WMCPR – ROLESVILLE, WENDELL, ZEBULON WATERSHED MANAGEMENT CONSTRUCTION PLAN DISAPPROVAL

Project Name	The Preserve at Moody Farm	Watershed	Lower Neuse	Jurisdiction	Rolesville
Date Received	12/16/2024	Date Processing Initiated	12/16/2024	Disturbed Acreage	40
S&E Permit Number	SEC-137379-2024	S&E Plan Review Fee	\$4,750 PAID \$5,252 PENDING	S&E Permit Fee	\$10,000 PENDING
SW Permit Number	SWF-137381-2024	SW Plan Review Fee	\$2,500 PAID	SW Permit Fee	\$2,500 PENDING

Plan Date/Revision Date: 04/07/2025

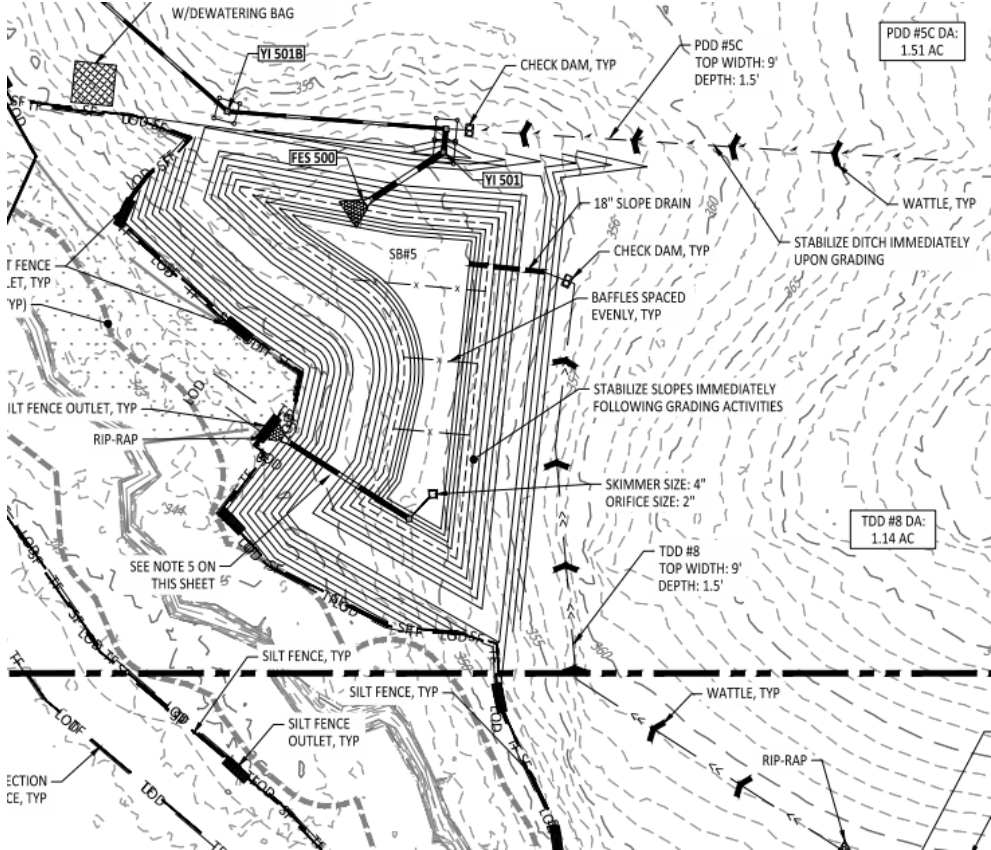
<input checked="" type="checkbox"/>	3.	<p>Notarized Wake County Financial Responsibility/Ownership Form (Required to initiate processing)</p> <p>-Since the FRP is a company please fill out item 2b, in part B.</p> <p>-Elliot Yadin does not appear as a manger or company official for the LLC, see image below. Please have the business registration site updated or fill out the signature authority form giving Elliot Yadin permission to sign this form.</p> <p>https://s3.us-west-1.amazonaws.com/wakegov.com.if-us-west-1/s3fs-public/documents/2023-03/Signature%20Authority%20Form-Watershed%20-%20Letterhead%20Form_0.pdf</p>  <p>-Provide letter of consent forms from <u>all property owners (5513 amazon trl. is missing)</u> giving permission to the financial responsible party to submit for permits and conduct land disturbing activities. https://s3.us-west-1.amazonaws.com/wakegov.com.if-us-west-1/s3fs-public/documents/2023-03/Landowner%20Consent%20Form%20Template%20-Fillable%20Form.pdf</p>
